# Access Compliance Report

## Public Rights-of-Way

### (Curb Ramps)

Intersection ID: 32147	Main Street: FOLIO CLUB DR	Cross Street: NEVERMORE_WY	Location: SW
ADA ID: 2ECE5201E3C2	Ramp Type: PerpDiag	Initial Pass/Fail: Fail	Overall Compliance: No
Severity Score: 47.5			
Codes/Mitigation Info/Possible Solution		Field Measurements/Component Compliance

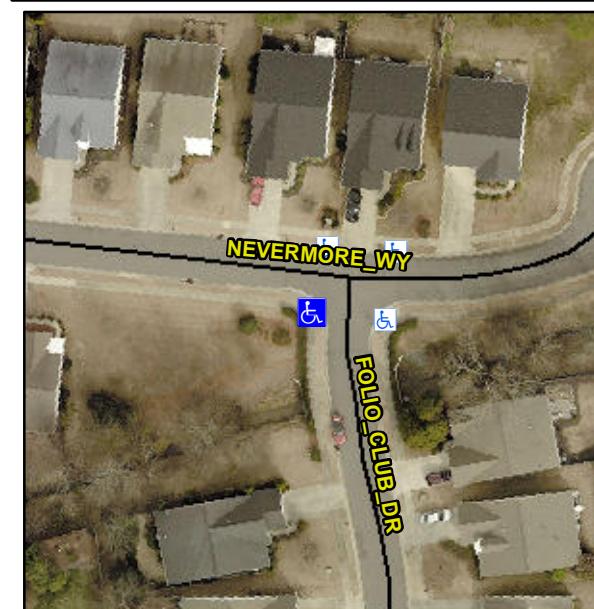
**Not Found, R304.5.1, R304.5.3**

Compliance	Description	Data	Compliance	Description	Data
N/A	Ramp Length (in)	47.0	Yes	Ramp Slope (%)	7.9
No	Ramp Width (in)	24.0	No	Ramp XSlope (%)	5.7
N/A	Flare Type LT	N/A	N/A	Flare Type RT	N/A
N/A	Flare Slope LT (%)	N/A	N/A	Flare Slope RT (%)	N/A
N/A	Flare Traversable LT?	N/A	N/A	Flare Traversable RT?	N/A
N/A	Landing Length (in)	N/A	N/A	DWS Provided?	N/A
N/A	Landing Width (in)	N/A	N/A	DWS Contrast?	N/A
N/A	Landing Slope (%)	N/A	N/A	DWS Length (in)	N/A
N/A	Landing X Slope (%)	N/A	N/A	DWS Full Width?	N/A
N/A	Landing Curb? (Y/N)	N/A	N/A	DWS Offset (in)	N/A
N/A	Shared Landing?	N/A			
N/A	Gutter Ponding?	N/A	N/A	Gutter Slope (%)	N/A
N/A	Gutter Lip Ht (in)	N/A	N/A	Gutter X Slope (%)	N/A
N/A	Painted X Walk1?	No	N/A	Painted X Walk2?	No
	X Walk 1 Direction	To SE		X Walk 2 Direction	To NE
N/A	X Walk 1 Width (in)	N/A	N/A	X Walk 2 Width (in)	N/A
	X Walk 1 Slope (%)	0.9		X Walk 2 Slope (%)	2.0
	X Walk 1 X Slope (%)	4.0		X Walk 2 X Slope (%)	0.7

**Remove & Replace Curb Ramp With Two New Directional Ramps or Equivalent.**
